Service Bulletin

Bulletin Number: AS29-08

Subject: Transfer Case Fluid Leak
Affected Models: 2007 XL7 (JC636)

Inspect for leakage at transfer case Weep hole

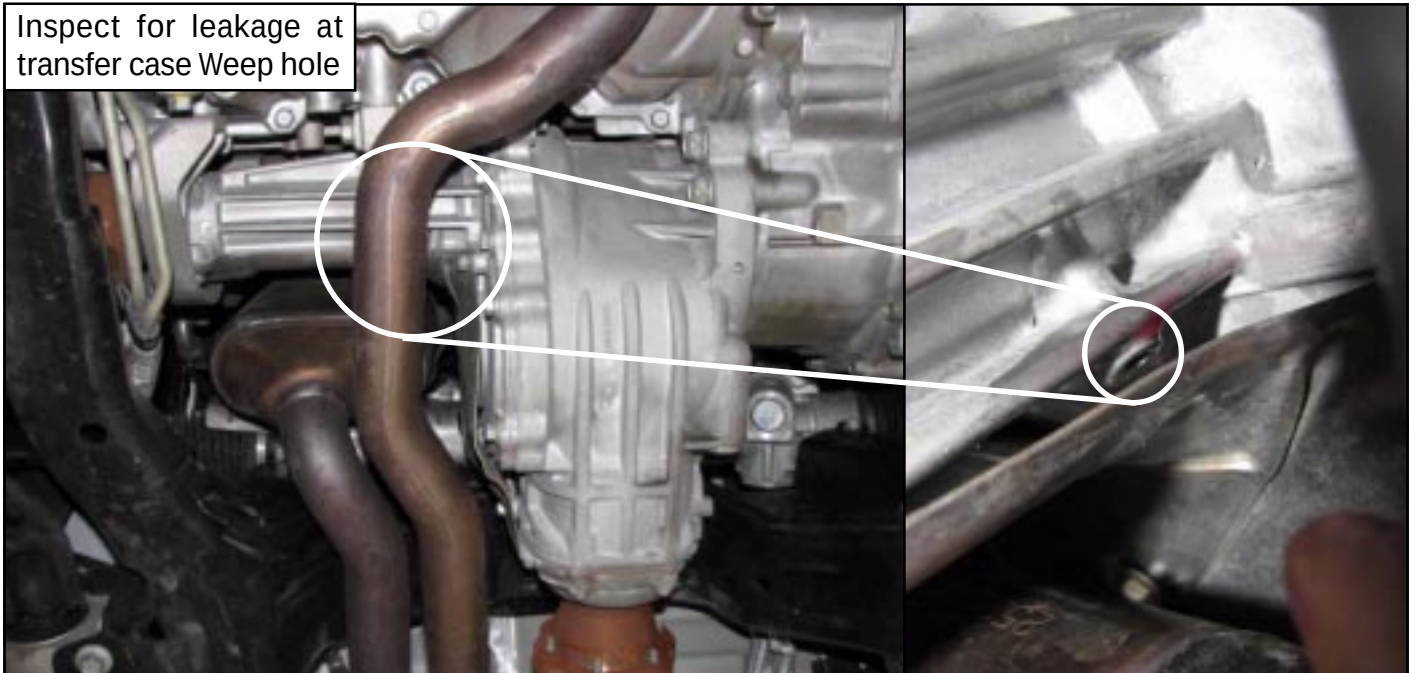
Automatic transmission fluid leaking from transfer case weep hole after vehicle sits overnight in temperatures colder than -10° C.

Transfer case intermediate shaft seal is leaking.

Raise the vehicle on a lift to inspect the transfer case weep hole for signs of automatic transmission fluid (red) leakage. If leakage is found, replace the intermediate shaft seal with the late type seal. Follow the procedures described in the "Transfer Case Replacement", "Transfer Case Disassemble", "Front Drive Seal Replacement" and "Transfer Case Assemble" sections of the 2007 XL7 (JC636) Service Manual and the "Seal Installation Tips" in this Service Bulletin. If no leakage is found at the weep hole, this bulletin does not apply.

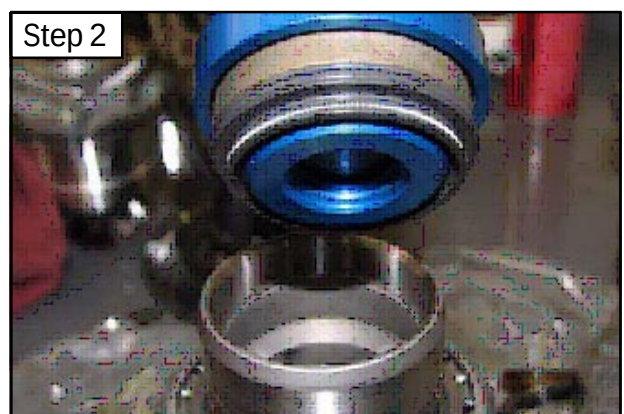
1. Install the new seal to the installer tool.

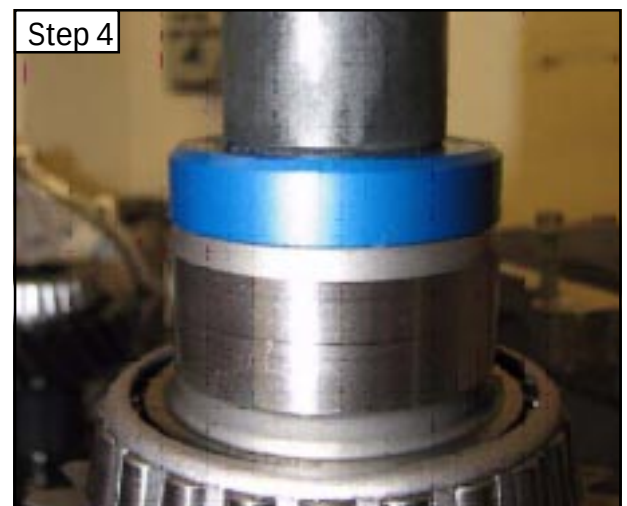
2. Place the seal and installer over the input shaft.

3. Drive the seal straight down into the input shaft.

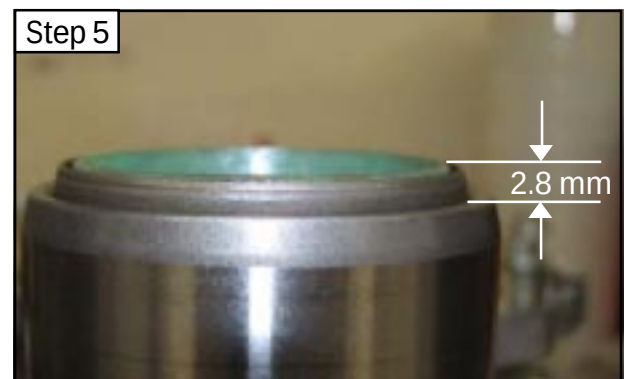
4. Stop driving when the seal installer tool comes into contact with the edge of the input shaft.

5. Confirm that the seal is correctly installed. A correctly installed seal will extend 2.8 mm upward around the entire circumference of the input shaft.
